Coronado
Business Class M2
> Cascadia
108SD/114SD

**Freightliner
Service Bulletin**

General Information

Fig. 1, Antenna and Roof Deflector Proximity

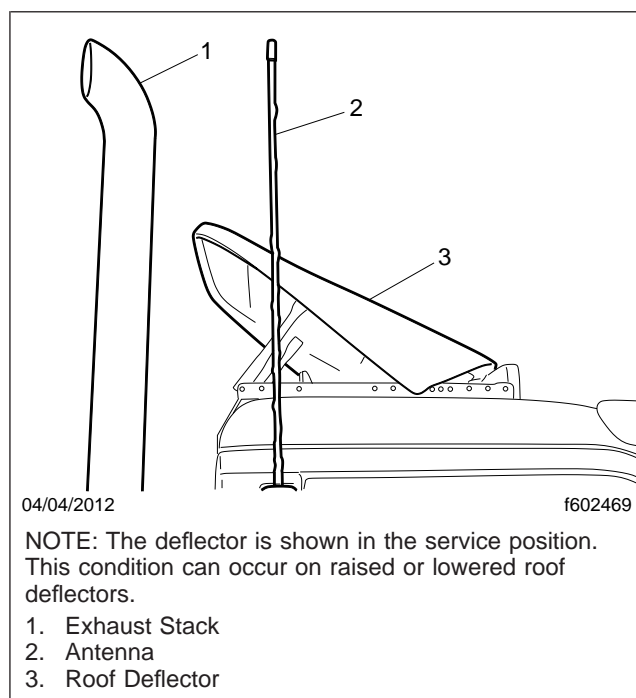
Cascadia daycabs with roof deflectors, built prior to April 2, 2012, may have a problem with the right-hand antenna hitting the roof deflector. See [Fig. 1](#). A thicker replacement antenna is available that resolves this problem. If the antenna is damaged by whipping against the roof deflector during vehicle operation, replace the antenna with part number PSO PFCPP504792.
